GOVERNMENT OF PUERTO RICO
PUBLIC SERVICE REGULATORY BOARD
PUERTO RICO ENERGY BUREAU

IN RE: REVIEW OF THE PUERTO RICO ELECTRIC POWER AUTHORITY INTEGRATED RESOURCE PLAN	**CASE NO.:** CEPR-AP-2018-0001 **SUBJECT:** Final Resolution and Order on the Puerto Rico Electric Power Authority's Integrated Resource Plan.

FINAL RESOLUTION AND ORDER ON THE PUERTO RICO ELECTRIC POWER AUTHORITY'S INTEGRATED RESOURCE PLAN

Figure 1. PREPA Planning Reserve Margin With Existing Resources and Forecast Peak Load, 2019-2038

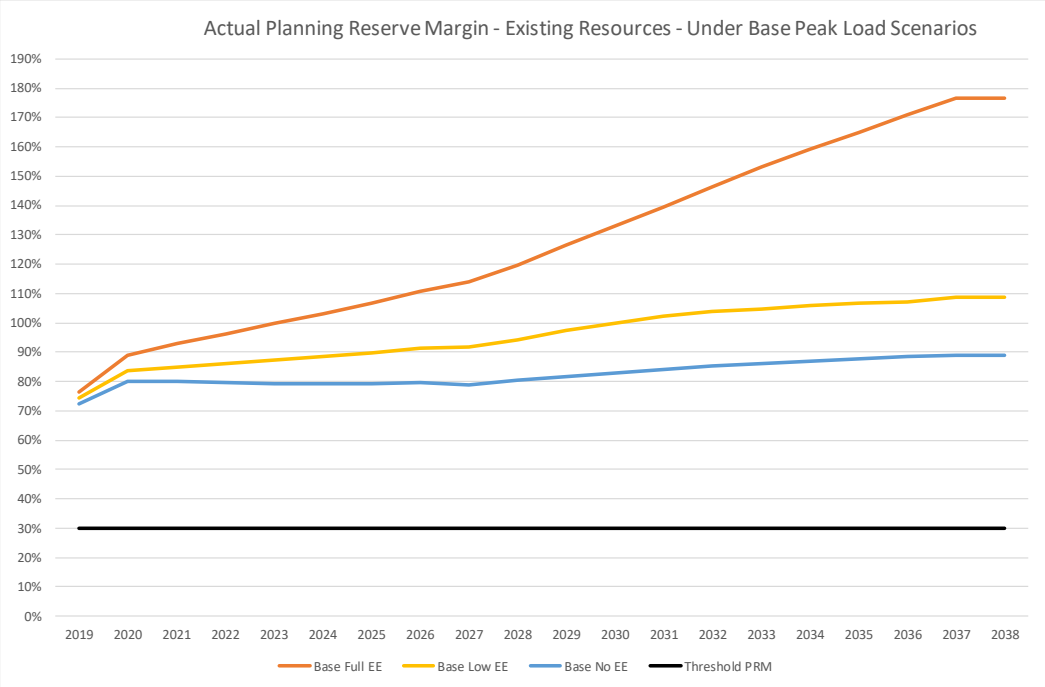
342. Figure 1 below incorporates PREPA's existing unit data (as seen in Table 3) and shows the PRM for the full existing fleet, under three different projections of peak load, for

343. As seen, the electric power system's overall PRMs in all three baseload cases (*i.e.*, baseload forecast with three different levels of applied EE) remain high, when counting all of the existing capacity and prior to considering availability and potential retirement, closure, or contract cessation for some resources.[349] For the baseload projection with full EE, the PRM steadily increases, to well over 100% and reaching 160% by 2034. The highest load forecast, with no incremental EE, leads to reserve margins of 89% at the end of the period.

Figure 2. Planning Reserve Margins Under Limited Availability of Certain Existing Resources

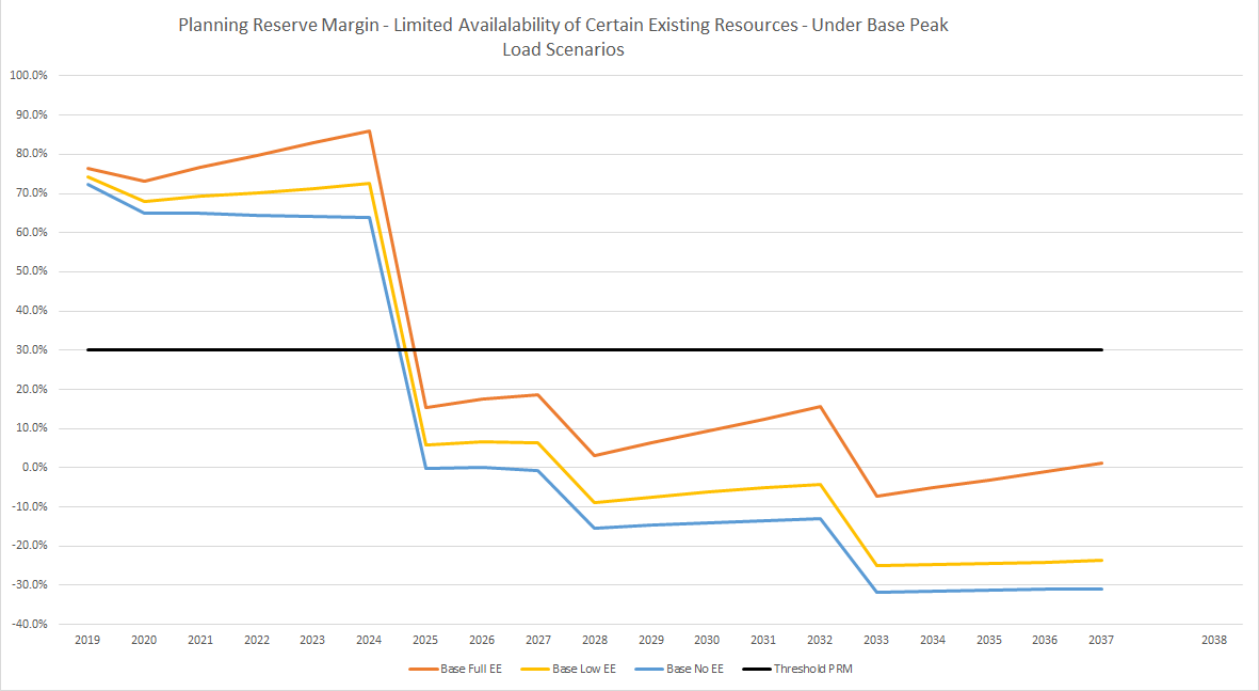
345. Figure 2 below illustrates PRMs on the system assuming that: (i) all MATS-impacted units retire by the end of 2024 (Aguirre 1&2, Palo Seco 3&4, San Juan 7&8); (ii) Aguirre CC units 1 & 2 retire by the end of 2024; (iii) that roughly half of the older GT units are not available as of 2020; and (iv) that Costa Sur 5&6 are returned to service, AES closes at the end of 2027, and the EcoEléctrica contract is not renewed after 2032.[351]

352. The PRM is high when counting all of the existing capacity but is much lower when both Costa Sur 5&6 and MATS-affected resources are unavailable, and when capacity is lost with AES and EcoEléctrica contract cessation, as seen in Figure 4 and Figure 5 above. This outcome indicates that increasing headroom (beyond minimum requirements) for economic retirement of MATS-impacted units will occur only after capacity installations.[355] Capacity installations are represented by the battery resources chosen in S4S2 and S3S2 and seen in Figure 4 and Figure 5.

Figure 3. PREPA Annual Net Position, MW, Existing Resource Base with Projected Closures, Retirements, and Reduced Availability

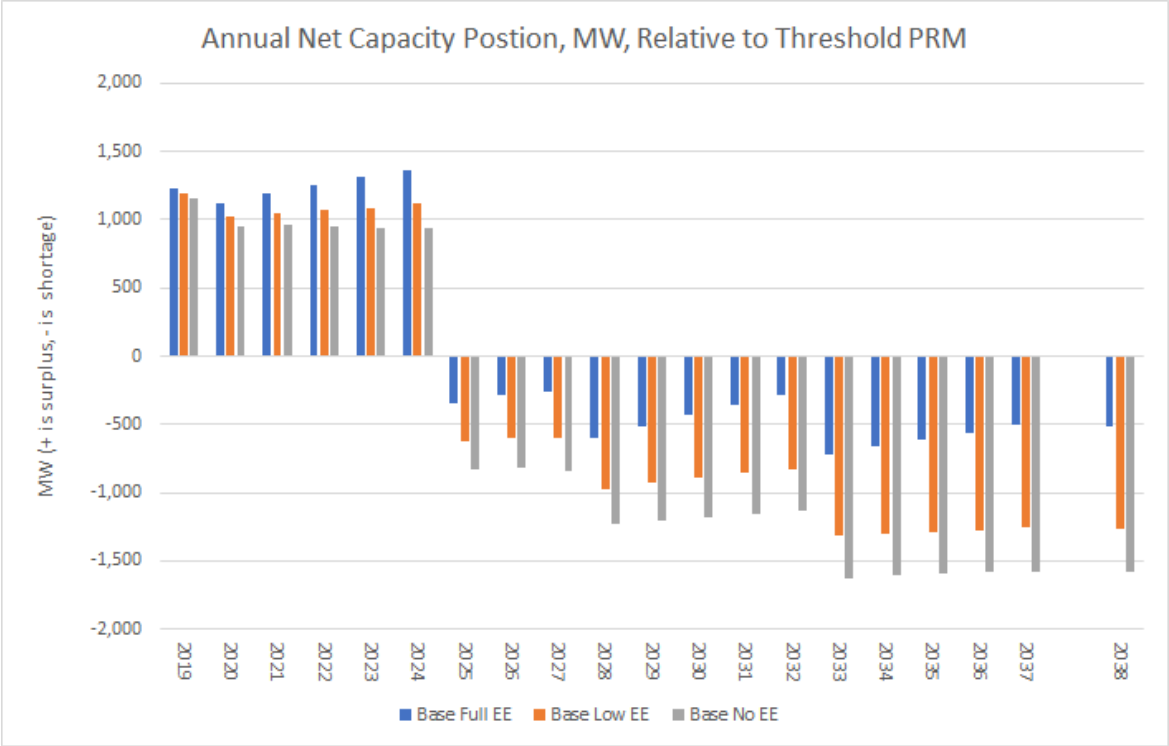
347. PREPA's "annual net position"— *i.e.*, the amount of capacity (surplus or shortage) relative to the threshold PRM—is readily derived from PREPA's resources and load forecast data. Figure 3 below shows a range of the annual net position for the PRM circumstance illustrated above in Figure 2, for the three different "base" peak load forecasts.

348. Figure 3 above illustrates the range of capacity need PREPA faces given its load forecast outlook, and its existing resource base. The following observations can be made:

Figure 4. Annual Net Position with S4S2 Level of Battery Additions

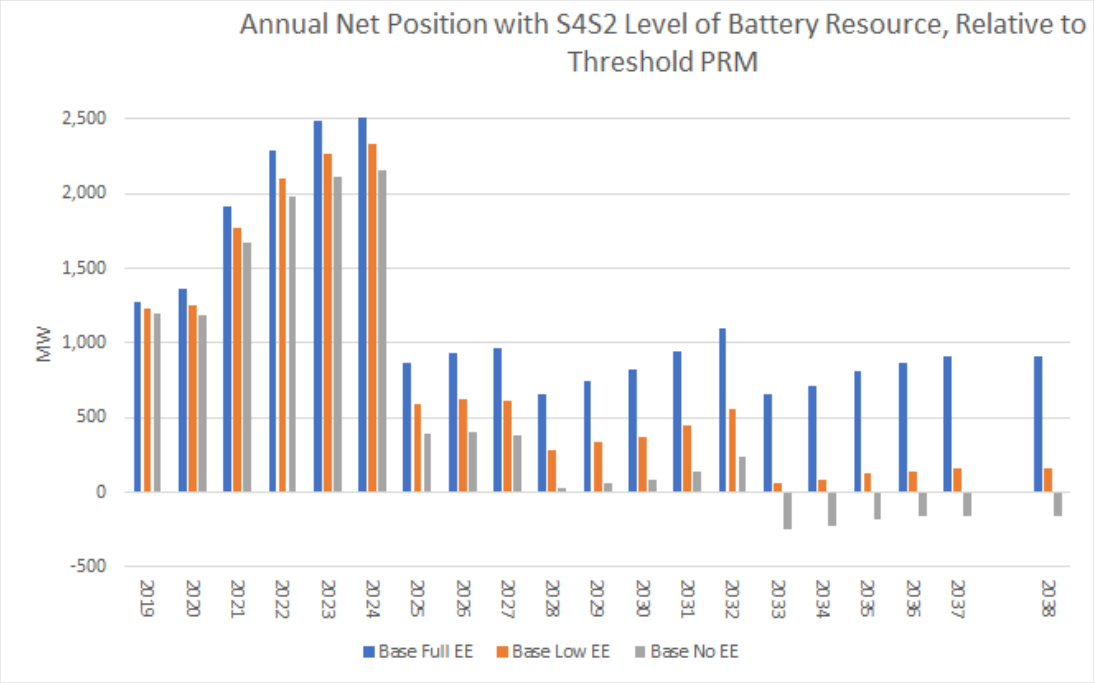
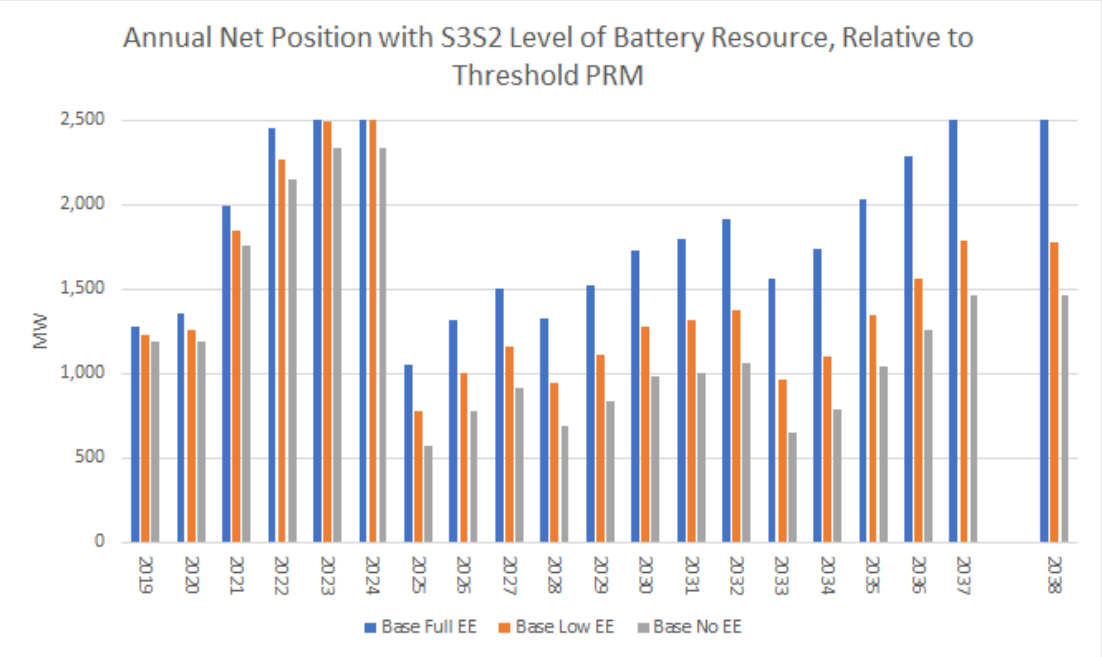
351. Figure 4 and Figure 5 above illustrate that batteries alone, without new fossil-fired capacity, could allow minimum PRM capacity needs to be met as MATS-impacted units retire, and assuming Costa Sur 5&6 remain in service (with any retirement or closure of return to service of either or both Costa Sur units, for the year or years in which they might retire, the "headroom" above minimum requirements is decreased). Higher levels of EE, as seen in the "Base Full EE" columns above, allow for the minimum reserve margin to be met with lower levels of battery installation because the peak load in Base Full EE scenarios is lower than in the other Base Low EE and Base No EE scenarios. Figure 5 also illustrates the importance of higher levels of peak load reduction from EE, and the presence of more battery capacity, in the later years when capacity from AES and EcoEléctrica may not be available. Figure 4 and Figure 5 show that with No EE or Low EE, 2025 and 2026 are critical years in the early portion of the planning period, when PRMs are at their lowest.

353. This analysis further indicates that new gas-fired peaker replacements are not necessarily required for PRM purposes. This outcome assumes that: if it is assumed that battery resources of a similar scale as required in PREPA's scenarios will be installed – first - in accordance with the early-year timelines in those scenarios; and that the capacity at Costa Sur 5&6 remains at least until such battery resource installations allow PREPA's annual net position to be higher than the Costa Sur units' output, which is seen in Figure 5 as occurring as early as 2025, provided that peak reductions from "full" EE resources are captured. The exception to this finding, that gas-fired resources are not needed, exists only if one abides by PREPA's definition of capacity need under the proposed MiniGrid construct. That construct imposes effectively higher PRMs on the system and directly states that "thermal" or fossil-fired resources are required.[356]

Figure 6. Henry Hub Forecast: PREPA, AEO 2018, and AEO 2020 ($/MMBtu nominal)

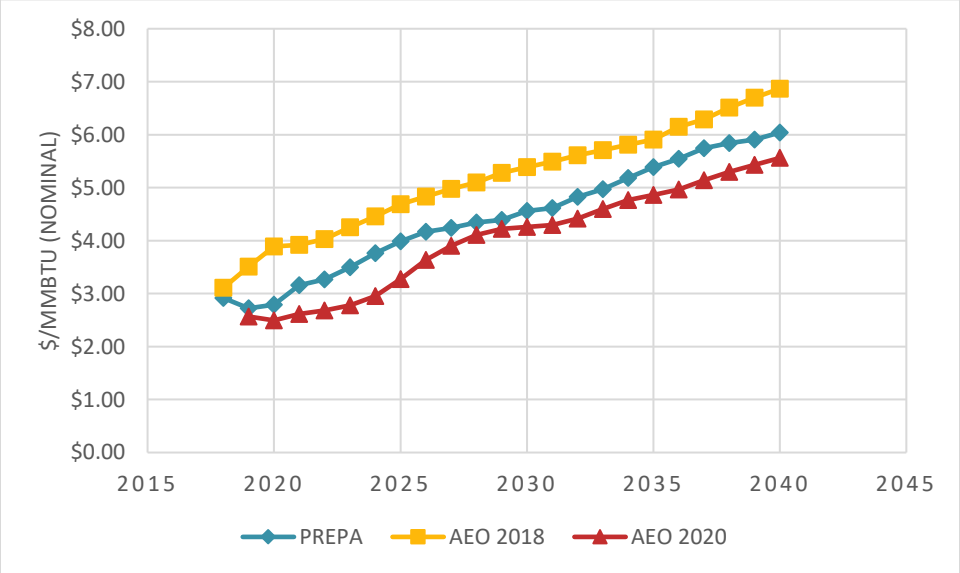
541. In the Proposed IRP, PREPA noted that the forwards were used for the first 18 months of the Proposed IRP period and then blended with its longer-term forecast for the next 18 months.[702] PREPA's longer term natural gas forecast was lower than the AEO 2018 forecast. In January 2020, EIA released AEO 2020, which contained an updated natural gas forecast but does not account for the current impacts of the COVID-19 pandemic.[703] The following graph compares PREPA's Proposed IRP forecast with AEO 2018 and AEO 2020.

Figure 7. WTI Forecast: PREPA, AEO 2018, AEO 2020, and STEO June 2020 ($/barrel nominal)

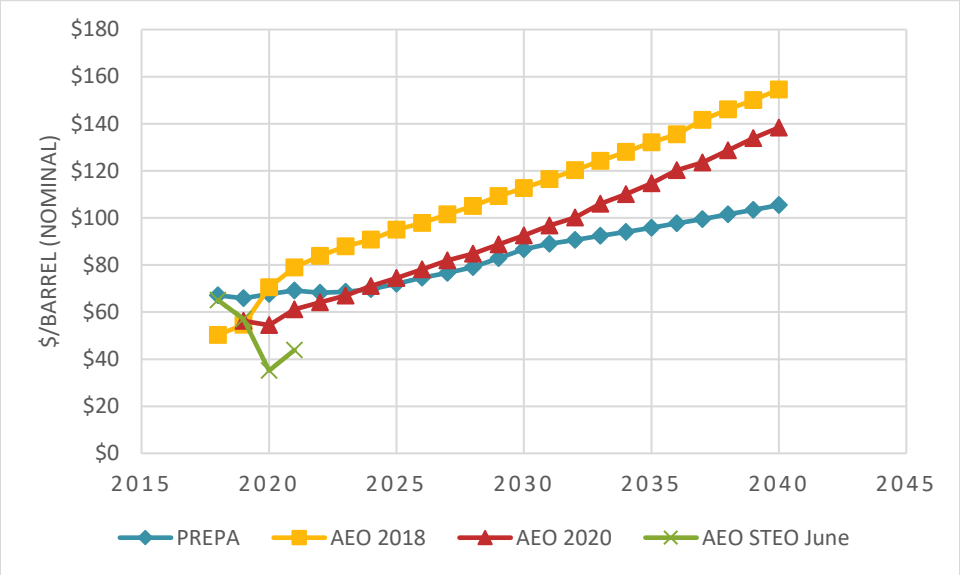
545. PREPA's IRP crude oil price forecast is between the AEO 2018 (higher) and AEO 2020 (lower) values for the first few years. All three forecasts are much higher than the short-term outlook through 2021. Beyond 2025, PREPA's forecast is lower than both the AEO 2018 and AEO 2020 forecast. At this time, PREPA's crude oil appears reasonable given the uncertainty surrounding the impact of COVID-19 and the global demand for crude oil. Accordingly, the Energy Bureau **ACCEPTS** the IRP's crude oil fuel forecast.
